NOTICE OF MEETING

The City of Lake Elmo
Planning Commission will conduct a meeting on
Monday September 9, 2019
at 7:00 p.m.

STAFF REPORT

TO: Planning Commission
FROM: Ben Prchal, City Planner
AGENDA ITEM: Variance Requests for 8126 Hill Trl. N
REVIEWED BY: Ken Roberts, Planning Director

APPLEWOOD POINTE OF LAKE ELMO Site Survey Analysis

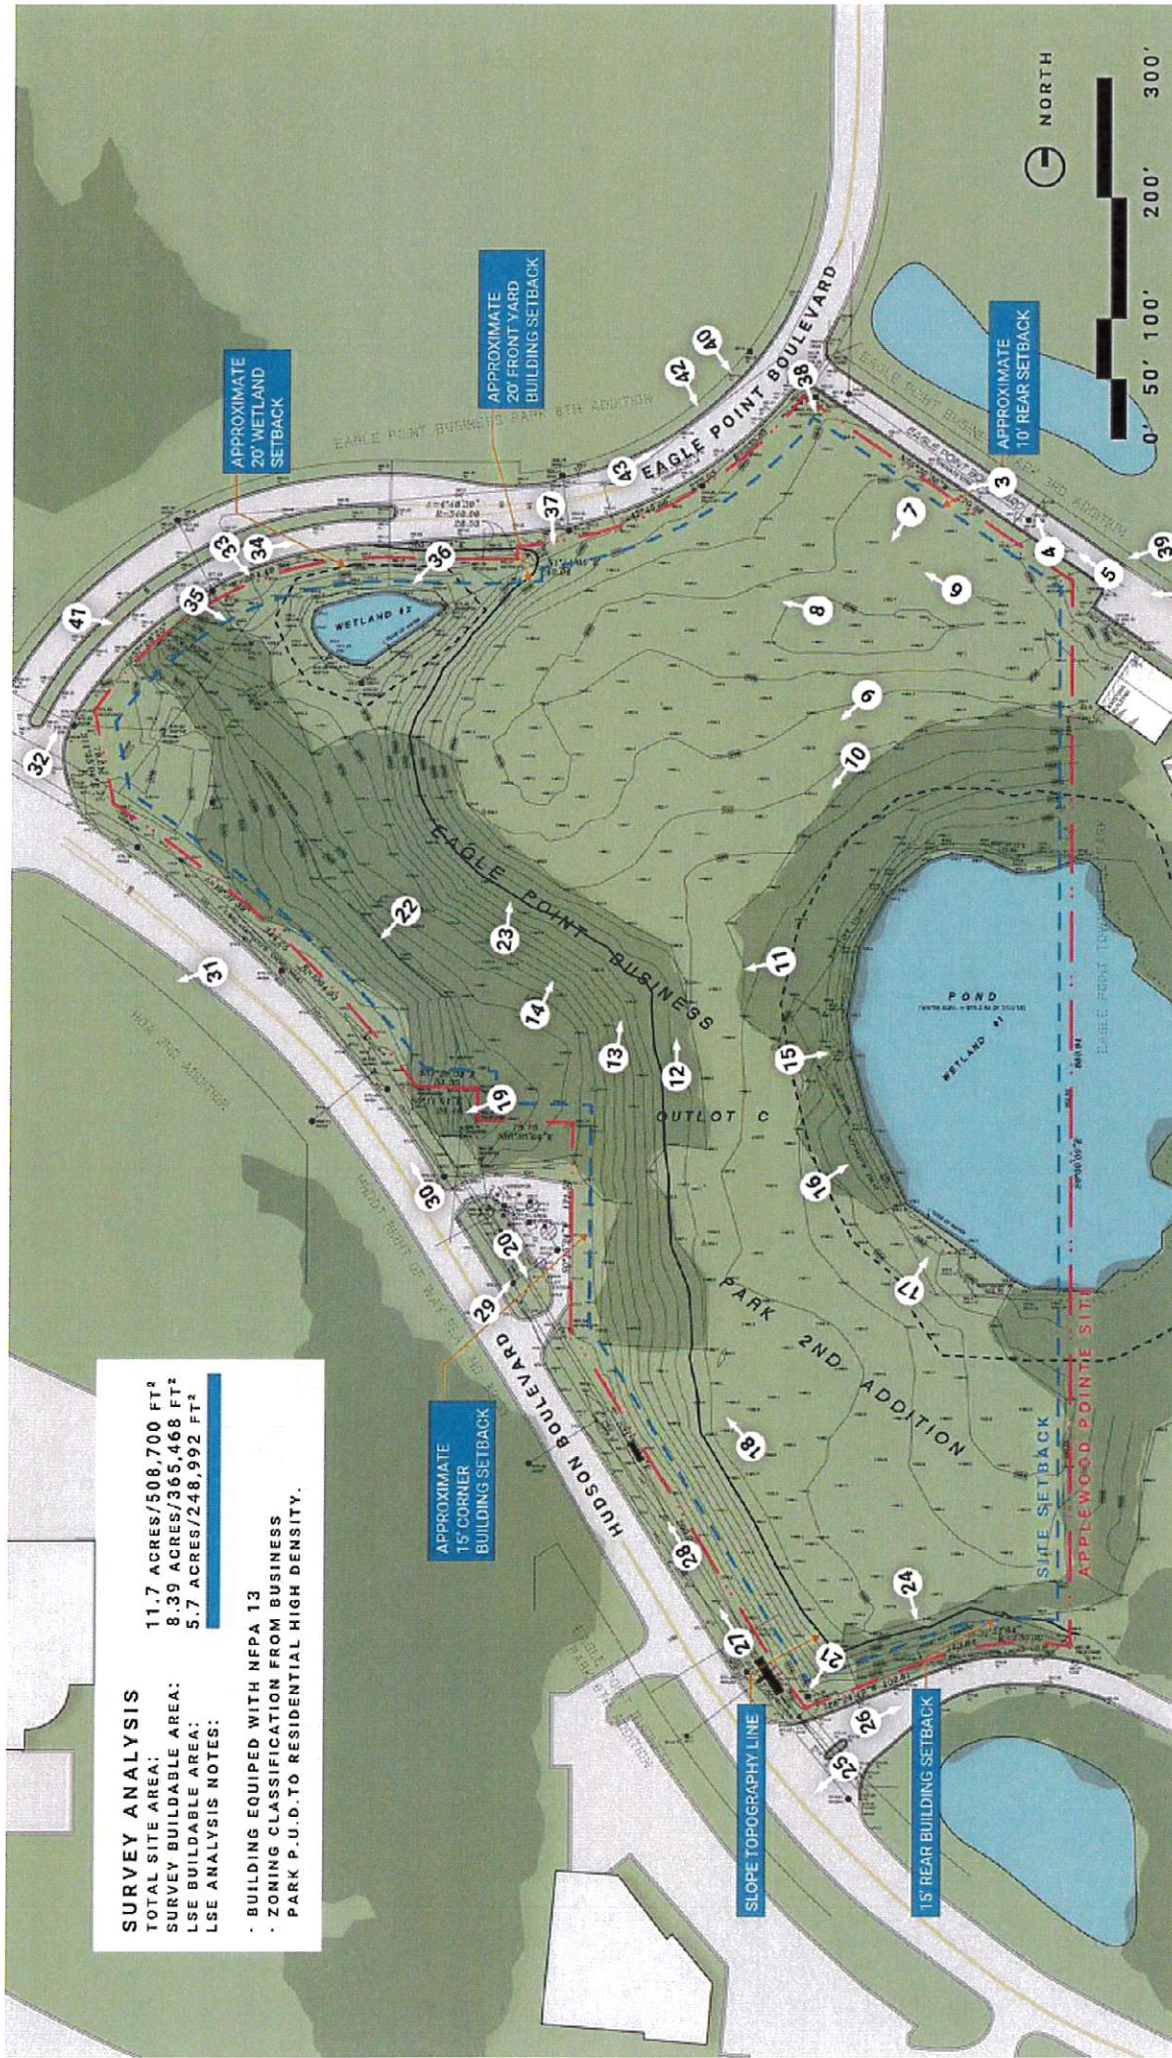
Site Character. The site is rolling with an elevation change of about 36 feet across the site – from an elevation of 962 near the sanitary sewer lift station along Hudson Boulevard to a high point of 998 in the north center of the site. There is a small wetland (0.15 acre) near Eagle Pointe Boulevard and a larger wetland (1.36 acres) that the eastern property line of the site runs through. There are areas of trees on the slope facing Hudson Boulevard and around the edges of the larger wetland.

Concept Site Plan

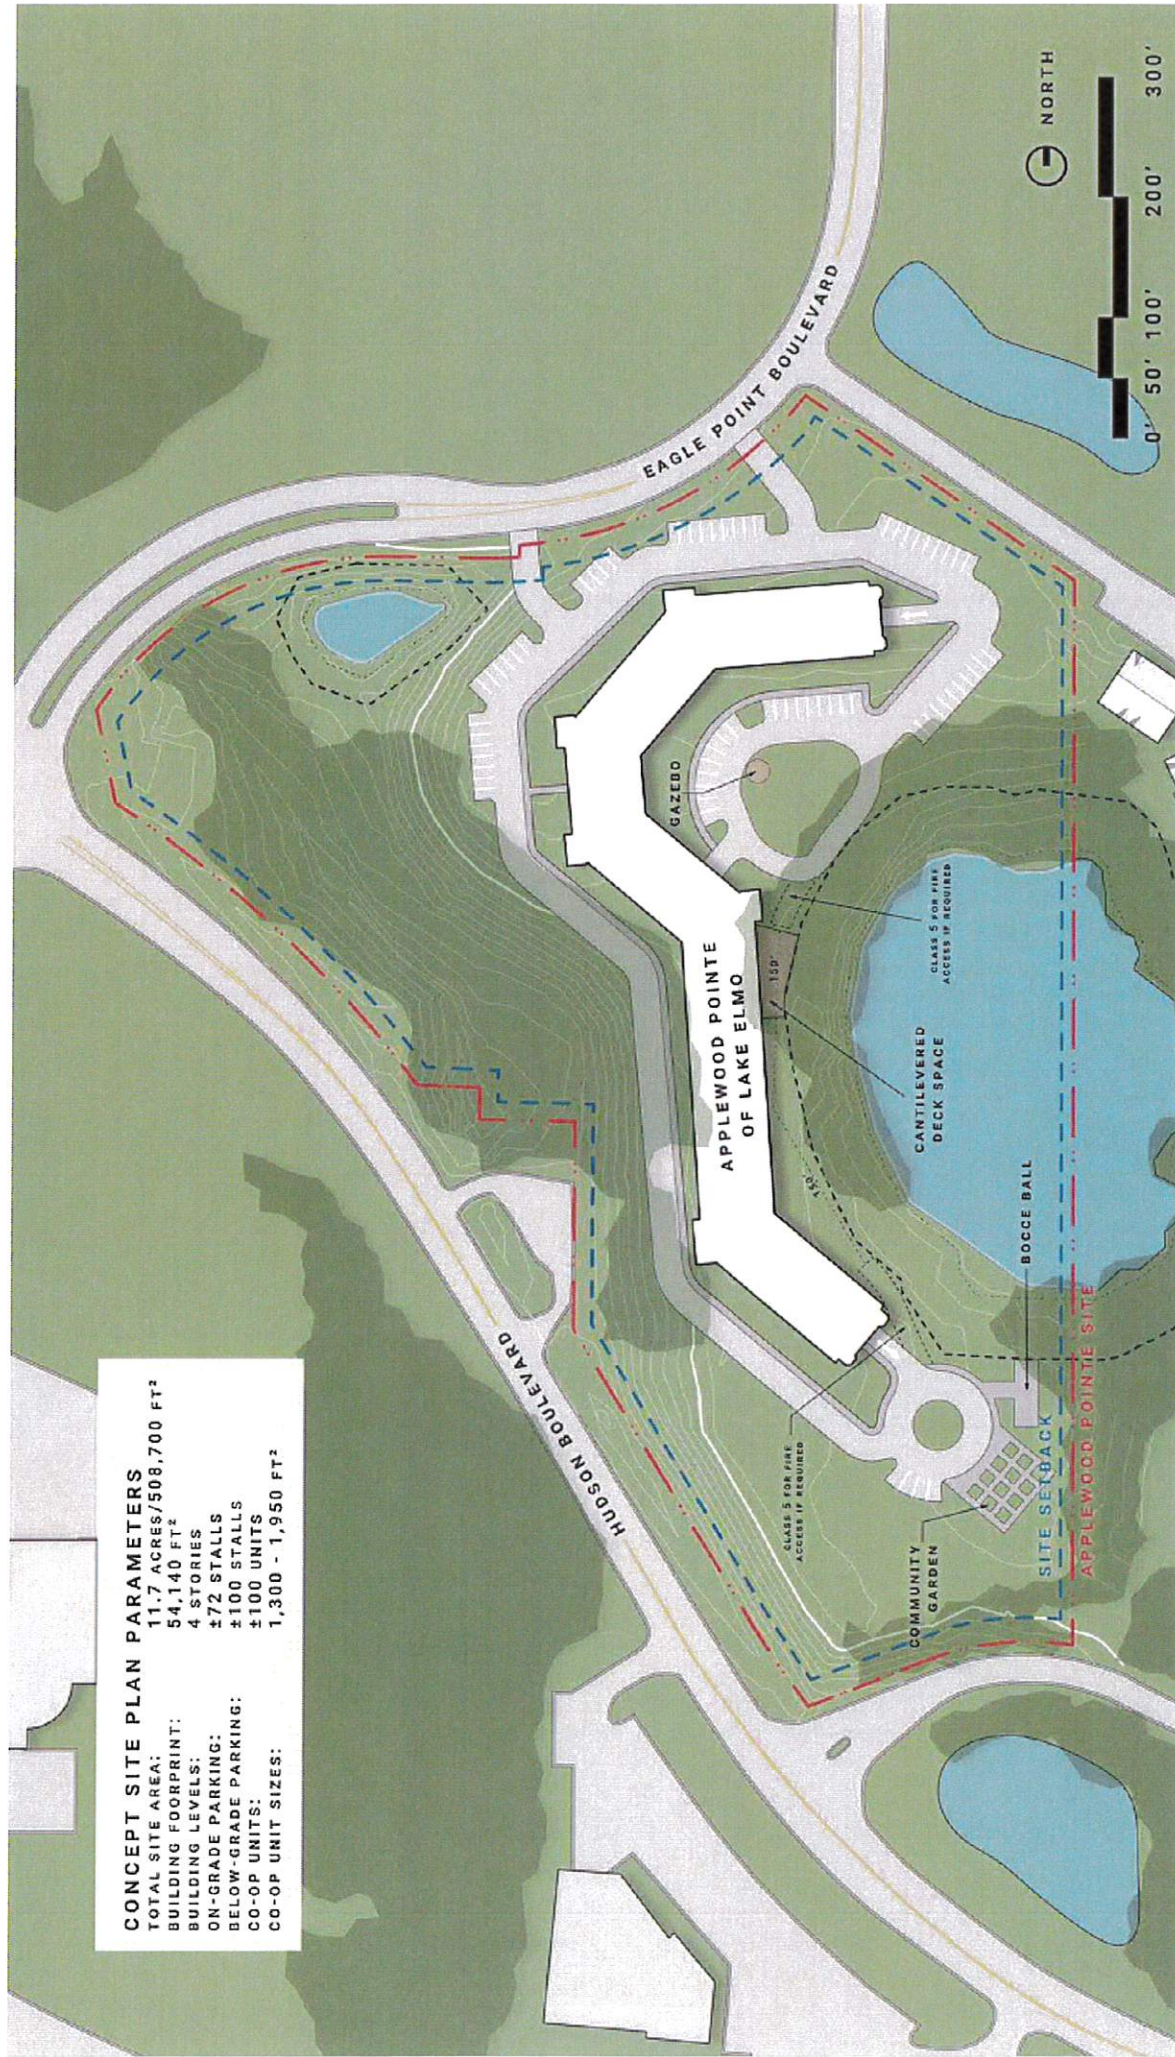
Site Plan. The concept site plan includes one 4-story building with 100 residential units, 100 below grade parking spaces and 72 on-grade (surface) parking spaces. This plan also shows areas for community gardens, bocce ball, a deck over-looking the wetland and a gazebo for the residents of the building.

Vehicular Access. The proposed concept plan shows two access driveways into the site from Eagle Pointe Boulevard. The spacing of the proposed driveways in relation to the existing driveway to the north of site do not meet City standards. The City Engineer's review memo (attached) provides more details about streets, driveways and access for this site.

Setbacks. The concept site plan shows a site setback line around the perimeter of the property. The proposed location of the building should meet or exceed all City-required setbacks from the street rights-of-ways and the wetlands. The City will need to verify that the proposed parking spaces near Eagle Pointe Boulevard will meet the required setback of 10 feet from the street right-of-way.

Parking. The City's Zoning Code requires one parking space per studio and 1 bedroom unit, two parking spaces per 2 and 3 bedroom unit and at least one visitor space per four units. With the proposed mix of 100 units, the City Zoning Code requires the developer to provide at least 225 parking spaces on site (2 per unit (200 total) and 25 visitor parking spaces). In this case, the developer is proposing a total of 172 parking spaces – including 100 parking spaces in the proposed building and 72 surface parking spaces spread throughout the site.

5. That the applicant address all comments in the City Engineer's Memorandum dated September 3, 2019 with the future preliminary plat and preliminary PUD Plans submittal. These include completing a traffic impact study, having only one driveway for the site, installing a public trail along Hudson Boulevard and managing all storm water on the site.
